## Draft amendment to ECE/TRANS/WP.29/GRSP/2010/26

The text reproduced below was prepared by the expert from France as a result of the last meeting of the informal group on child restraints systems (CRS) regarding a proposal for a new Regulation on CRS.

### **Draft new Regulation on uniform provisions concerning the approval of enhanced child restraint systems used onboard of motor vehicles**

6.3.4.1. ~~Support leg contact volume requirements~~

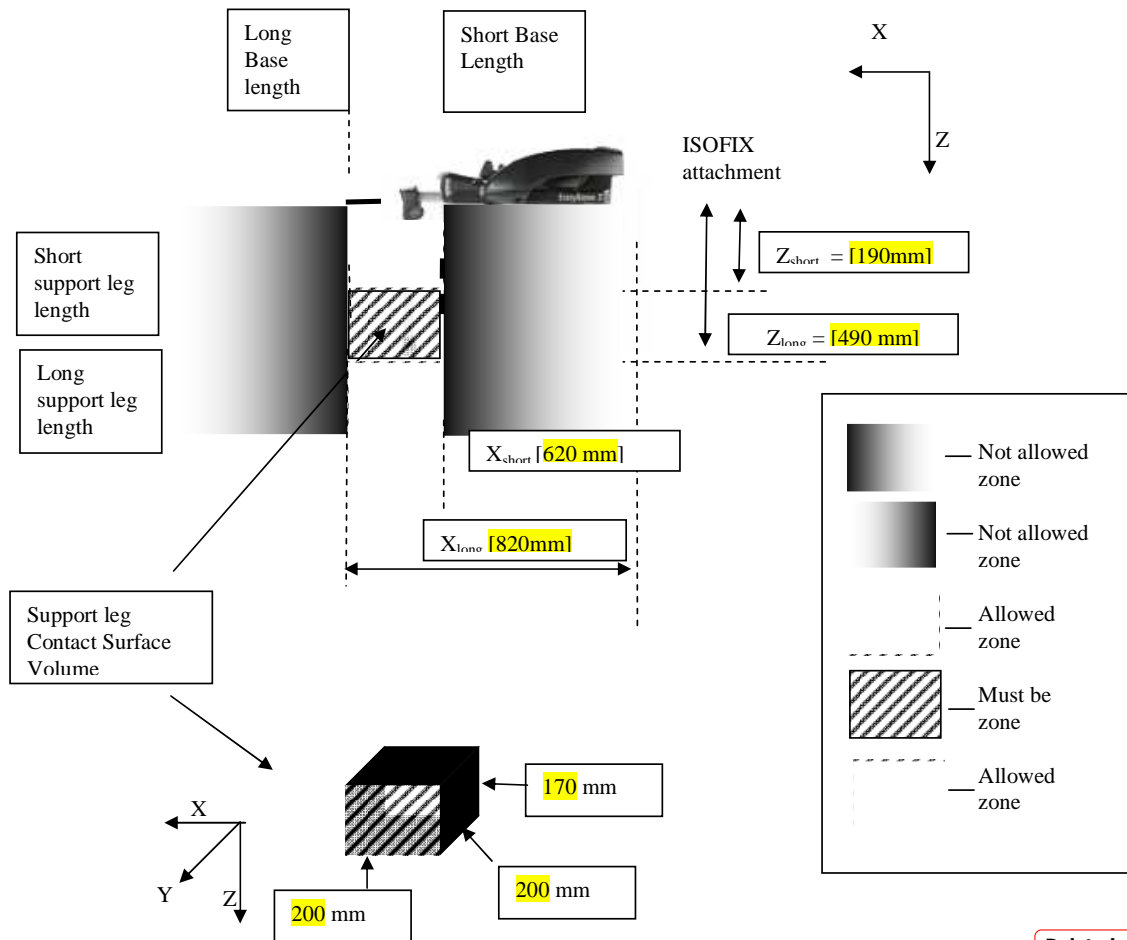
- X  $X_{short}$  must be [620] mm or larger, from the ISOFIX anchor, measured in X direction.
- X  $X_{long}$  must be [820] mm or shorter, from the ISOFIX anchor, measured in X direction. Comment: could 820 mm be reduced to reduce vehicle contact volume? (probable interference with front seats)

- X The support foot is not required to have adjustment possibilities in X direction.
- X The support foot is not allowed to have a fixed position or adjustment possibilities lying outside the support leg contact volume in X direction (indicated in figure XY below with a shaded grey color; "Not allowed zone" ).

~~6.3.4.2. Artificial vehicle jig for CRS~~

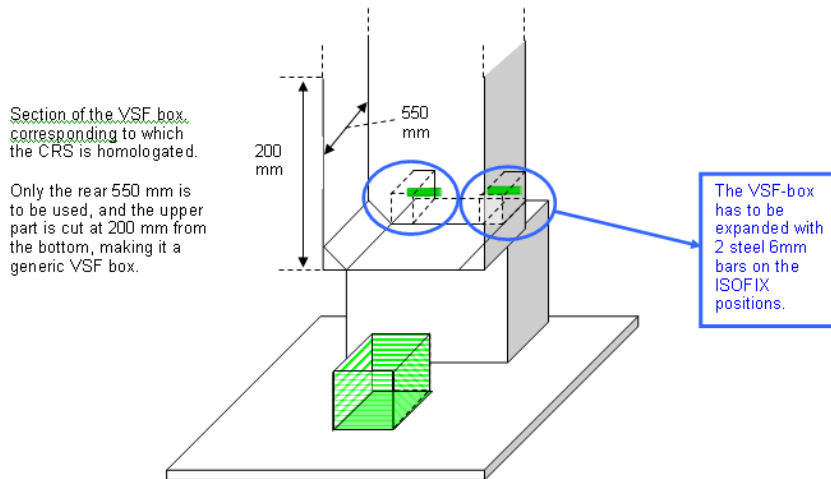
comment: be careful, that these requirements are not in contrast with the requirements of 6.4.3.1.;
